SUBJECT: File No. 1251H2A-19 and 1251H2A-19
SITE INSPECTION - Response
Proposed Residential Building Site
1065, 1067 & 1069 E Bradley Avenue
El Cajon area, County of San Diego

Per your email of January 24, 2022, the additional information you requested is as follows:

5. Updated geotechnical report addressing the following review comments.

LOCATION OF EXPLORATION TRENCHES

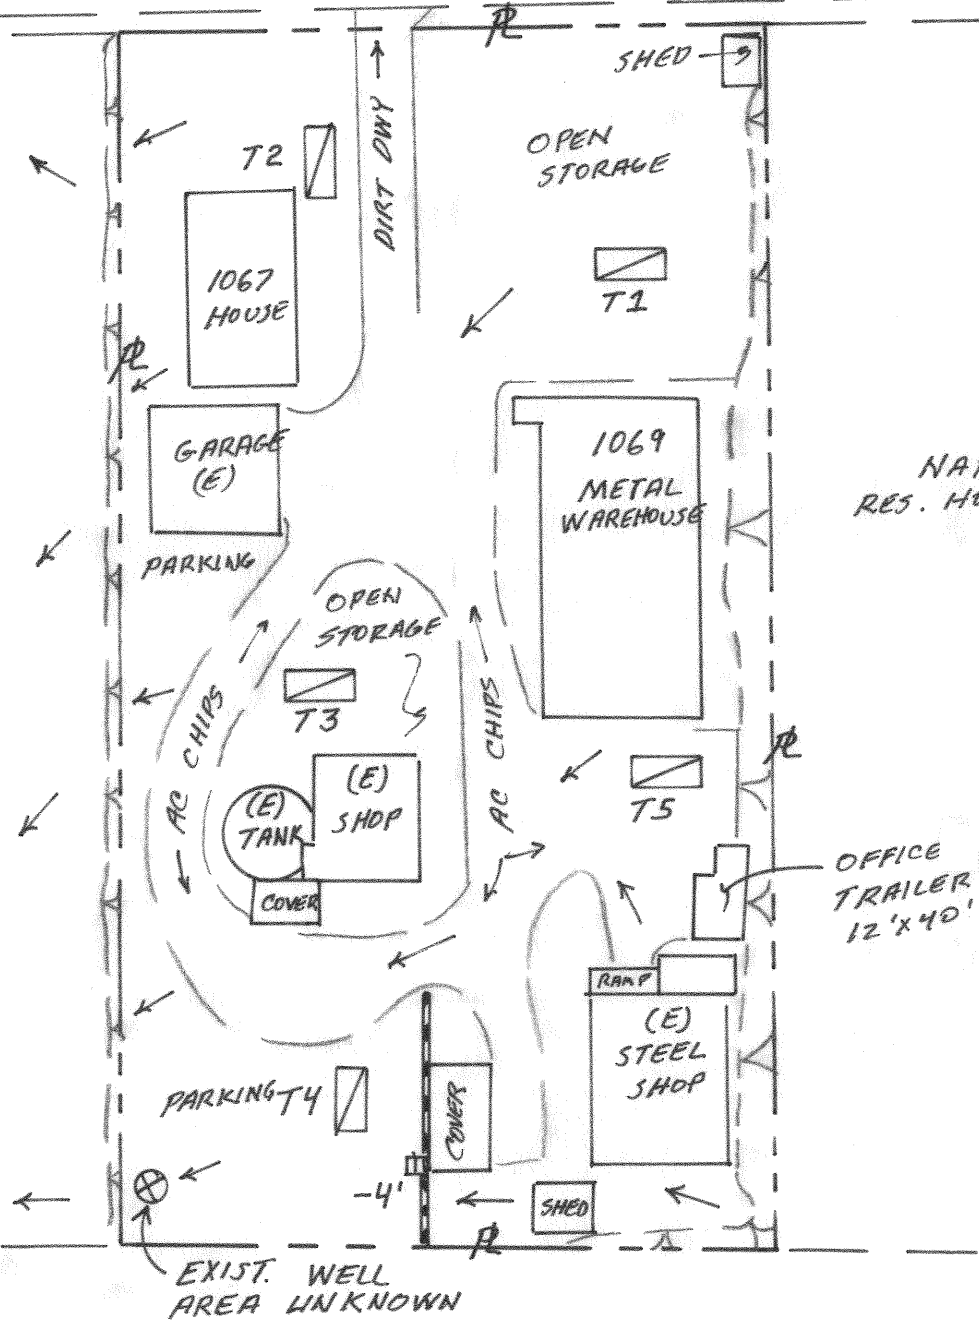
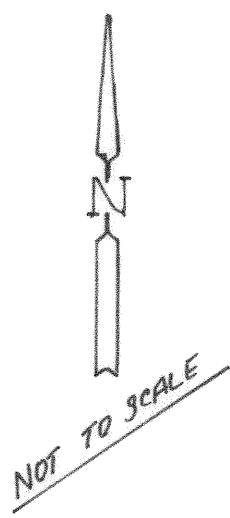
- d. Provide site investigation logs. Include a Geotechnical Map delineating geologic soil types and location of test pits and borings.

Please see attached updated reports with the logs and maps with the trench locations.
